S E R V I C E N O T E

8922B GSM BS Test Set

Recommended Removal of Hardware

Page 2 Service Note 8922B-01

FIGURE 1
Top Internal View of HP 8922A/B/E/G

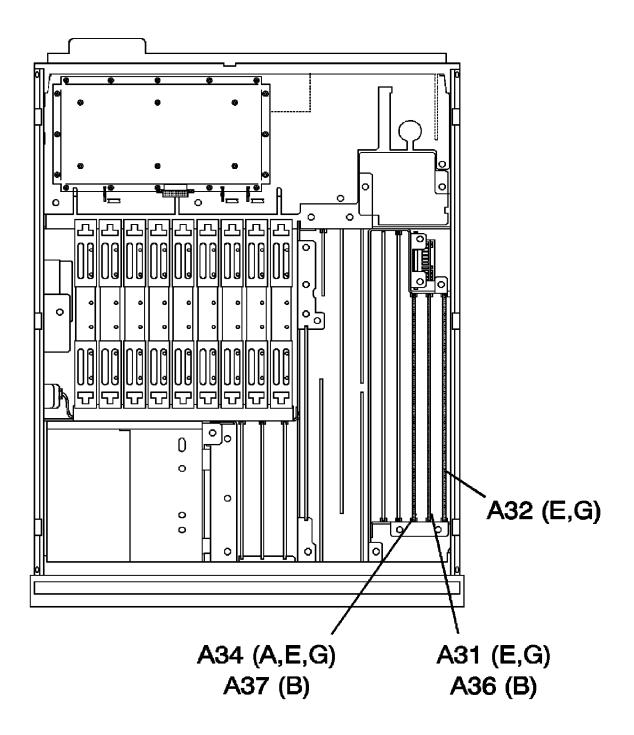
Instruments with serial numbers noted above may have internal hardware (screw and nut) which is improperly attached to the A36 FIFO GPIO and A37 Sequence Controller assemblies. Refer to Figure 1 for location of these assemblies. The hardware can become separated from the assembly, contact other circuitry and may cause electrical damage.
